REMARKSSpecification Amendments

Customer No. 33451
STOEL RIVES LLP
900 SW Fifth Avenue, Suite 2600
Portland, OR 97204-1268
Telephone: (503) 224-3380
Facsimile: (503) 220-2480
Attorney Docket No. 51306/757:1

Fig. 1
PRIOR ART

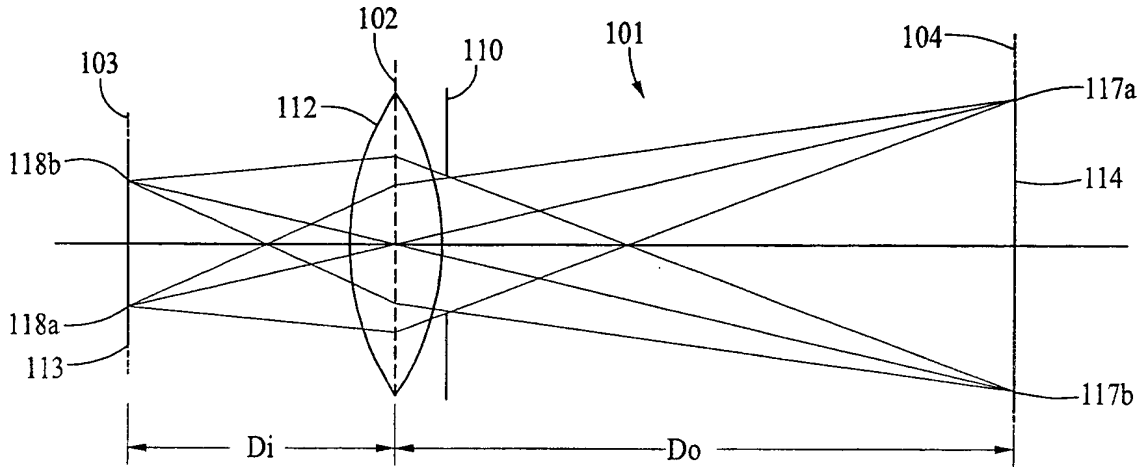
In each of Figs. 1-3 the notation "PRIOR ART" is added below the figure number. This same amendment was made in the parent to the present application as required by the Examiner therein. These amendments are included in the set of formal drawings filed concurrently herewith.
